SEWAGE DISPOSAL SYSTEM

MARYLAND STATE DEPARTMENT OF HEALTH*

HOWARD COUNTY
BUREAU OF ENVIRONMENTAL HEALTH
992-2330

11801 Wayneridge Street
Fulton, MD
Lot 3 Block B
Mooresfield

P 36003

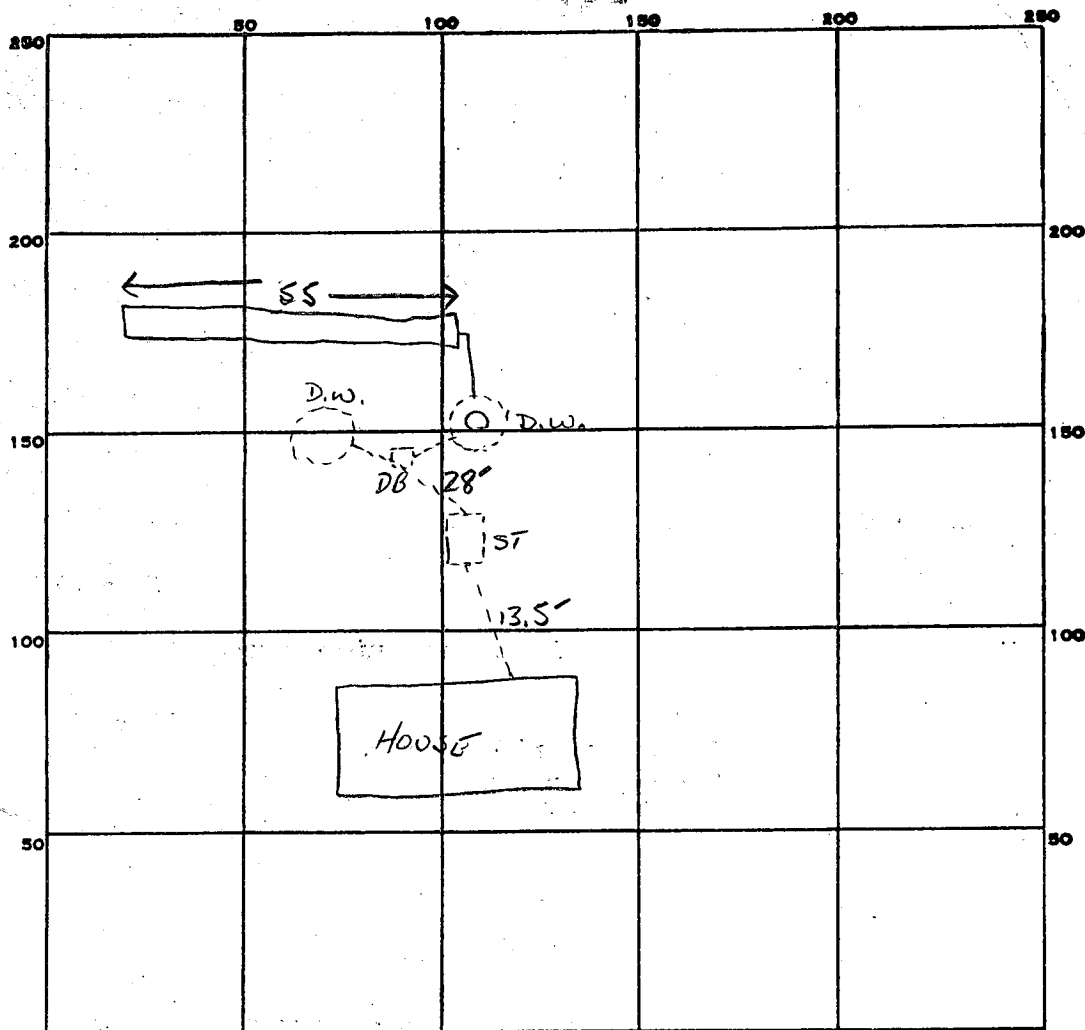
REPAIR - CALL FOR INSPECTION WHEN GROUND IS OPENED UP SO SANITARIAN CAN RECOMMEND

REPAIR. 3'-10' 7" STONE - SANDY LOAM SOIL AT 3'-10"

TRENCH OFF LOWER DRYWELL. SAND

REMARKS 9-19-85 OK TO ADD STONE TO TRENCH. SAGEL

LOCATION SURVEY OF:

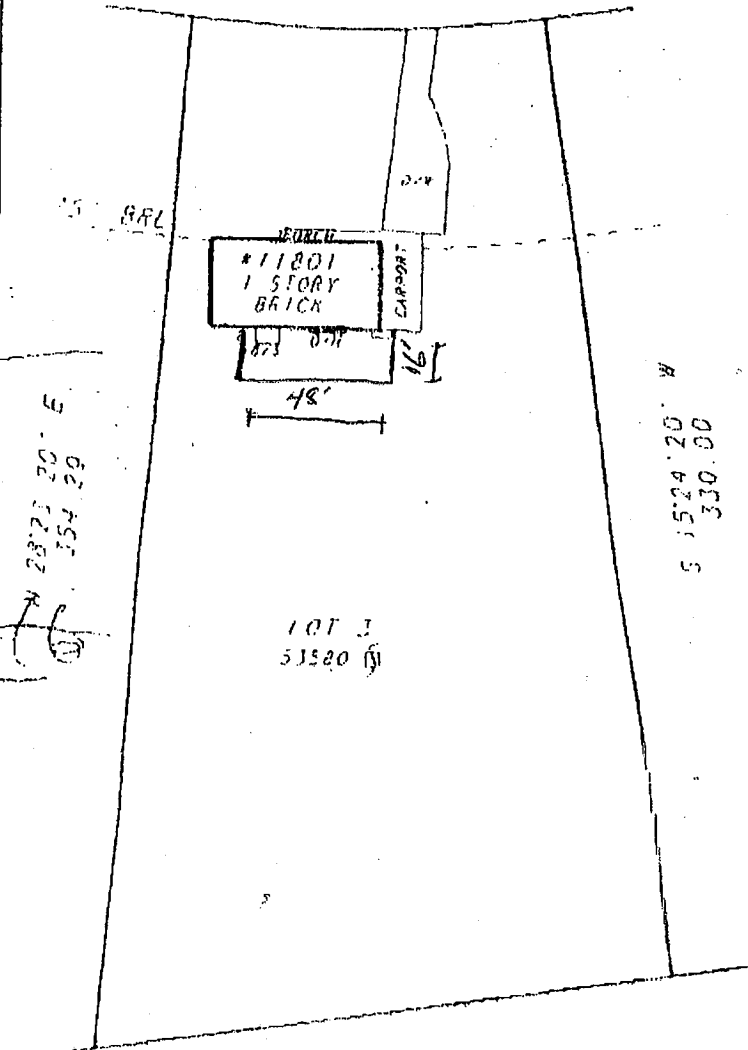
I would like to apply for a waiver on a request to build a deck within 10 feet of our septic tank. We agree that in the event the current tank would need to be replaced, we would relocate it more than 10 feet from the edge of the deck.

We feel that there is adequate access to service the tank in its current location once the deck is completed.

10/17/03- Proposal Acceptable

Adequate access ^{to tank} OK - (SRK)

COMAR not specific on
10' standard, access is the intent.
